**Staff Analysis of Proposed Amendment to the
Dane County Water Quality Plan, Revising the Environmental
Corridors of the Central Urban Service Area
in the City of Fitchburg**

Proposed Amendment to the
Dane County Water Quality Plan,
Revising the Environmental Corridors
in the Central Urban Service Area

Map 1 – Amendment Area

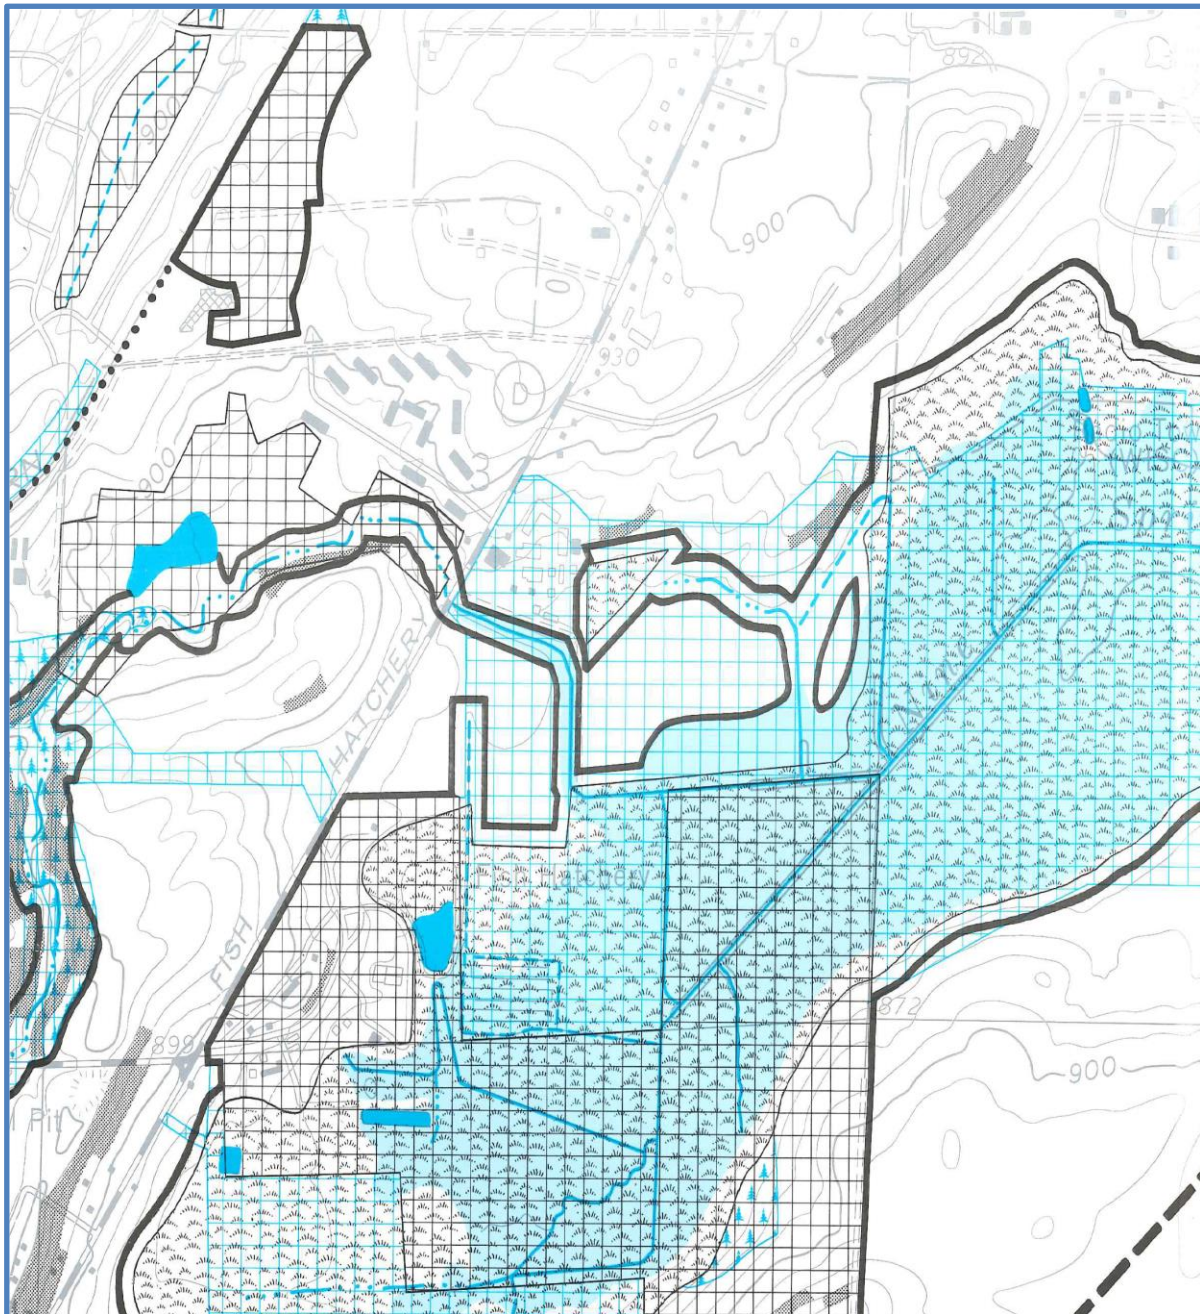
- The proposed project will increase the vegetated buffer area by 940 square feet over existing conditions for Nine Springs Creek south of the site while maintaining a minimum buffer width of 41 feet and up to and greater than the 75-foot buffer width required by CARPC’s adopted policies and criteria in some locations.

Map 3 – Proposed Site / Stormwater Management Plan

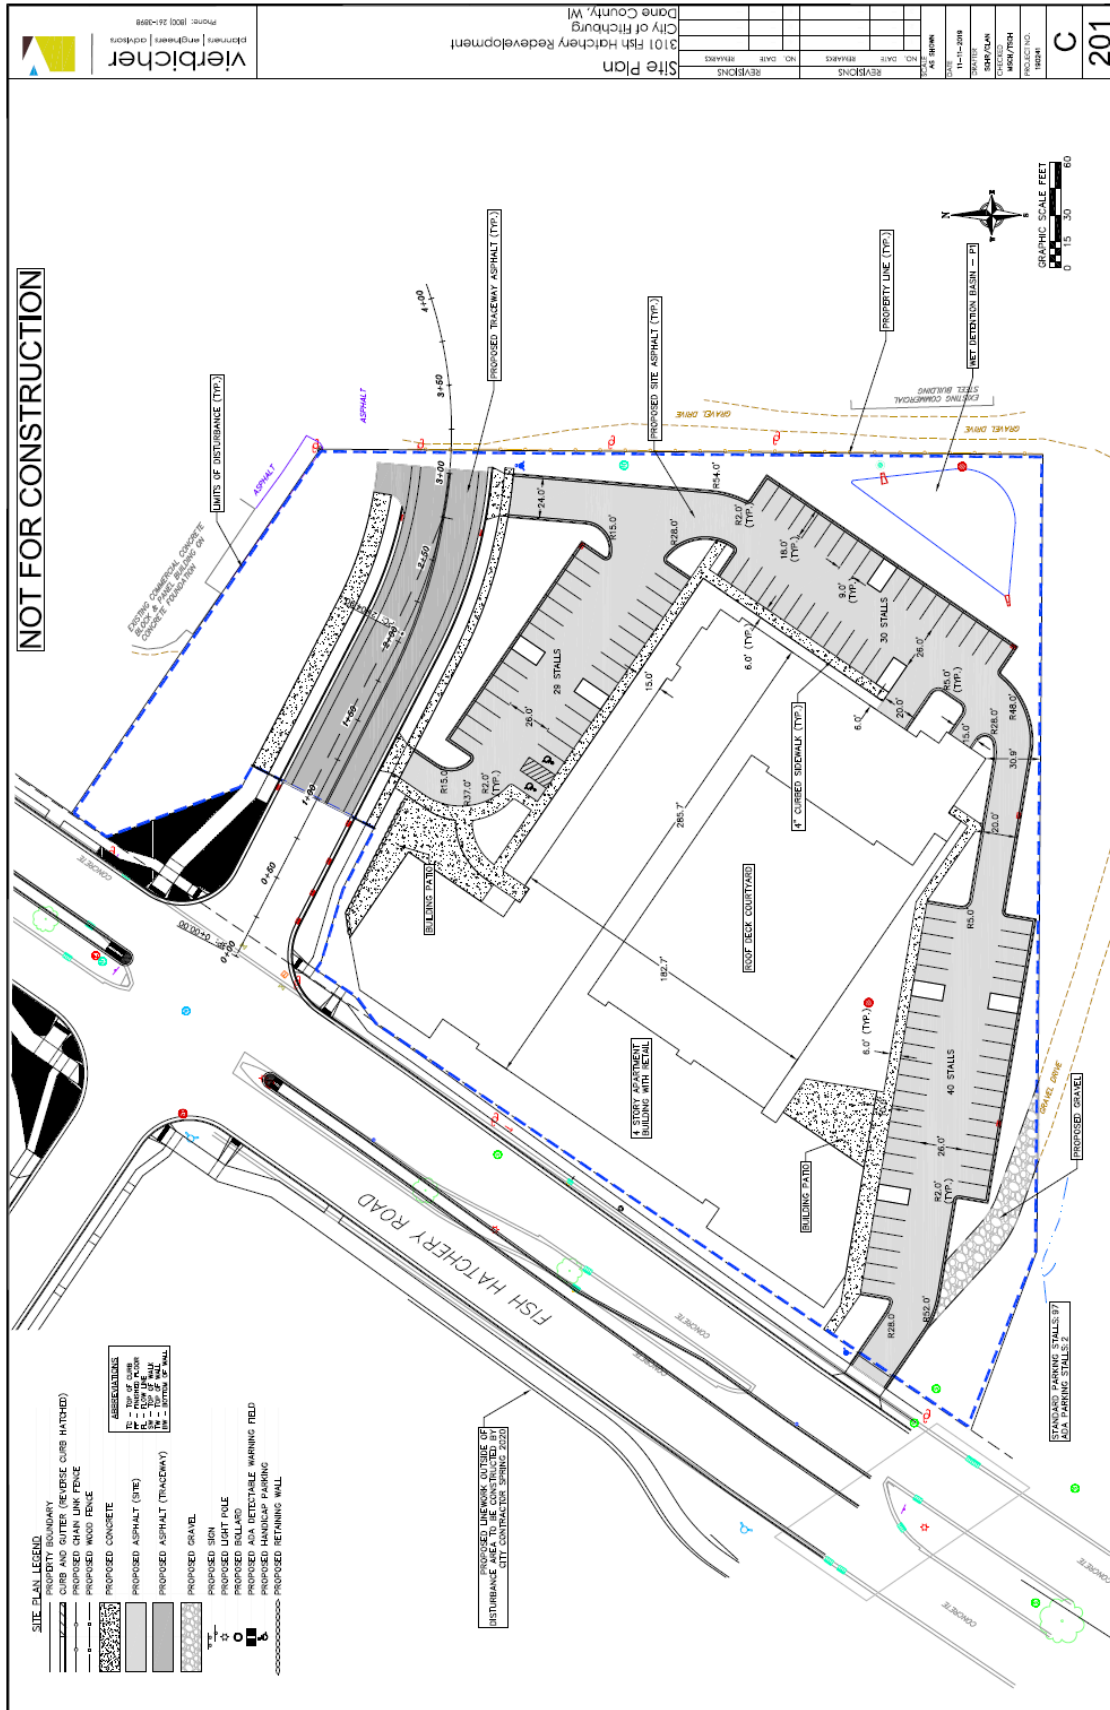
The 75-foot stream buffer reduction is proposed to be largely mitigated by the installation of stormwater management facilities to capture and treat stormwater runoff from most of the development and planting of native vegetation within the environmental corridor. Redevelopment sites are typically not required to provide the same level of stormwater management requirements as new development. However, the City of Fitchburg ordinance requires both redevelopment and new development sites to reduce, to the maximum extent practicable, total suspended solids load leaving the redeveloped site by 80%, based on the average annual rainfall, as compared to no runoff management controls. The ordinance also states that new parking areas only need to achieve 60% total suspended solids reduction. The proposed stormwater management plan includes an underground detention facility and a wet detention pond at the southeast corner of the site. In addition, should the eastern property owner be willing to abandon the existing gravel access drive as a result of better access to the extended portion of Traceway Drive to the North, the developer has committed to removing the existing gravel drive and restoring the area to native plantings. Infiltration, including the use of porous pavement, is not proposed as a result of the subsurface petroleum and commercial solvent contamination. However, the development is proposing to include a green roof, which will provide improved stormwater volume control compared to current conditions.

The proposed underground detention facility and wet detention pond will include outfall structures that tend to concentrate the flow. These concentrated flows can cause erosion and channeling where it discharges to the receiving waters. It is therefore important to design the discharge structures with level spreaders or similar practices to spread the flow and prevent channelization and erosion.

1. Submit a detailed stormwater management plan for CARPC and DCL&WCD staff review and approval prior to any land disturbing activities in the amendment area. The stormwater management plan shall include the following:

- a. Install stormwater and erosion control practices prior to other land disturbing activities.
 - b. Provide at least 80% sediment control for the amendment area for the 1-year, 24-hour design storm, in accordance with the City of Fitchburg Stormwater Ordinance.
 - c. Utilize a green roof to reduce stormwater runoff volume.
 - d. Provide level spreaders or similar practice to spread the flow of water discharging toward the riparian buffer.
2. Require that the environmental corridor stream buffer be established in dense, grassy, native vegetation, maintained at a height of at least 6 inches.
3. Work with the eastern property owner to establish an egress route to the north such that the existing gravel access drive / easement can be abandoned and restored to native vegetation.
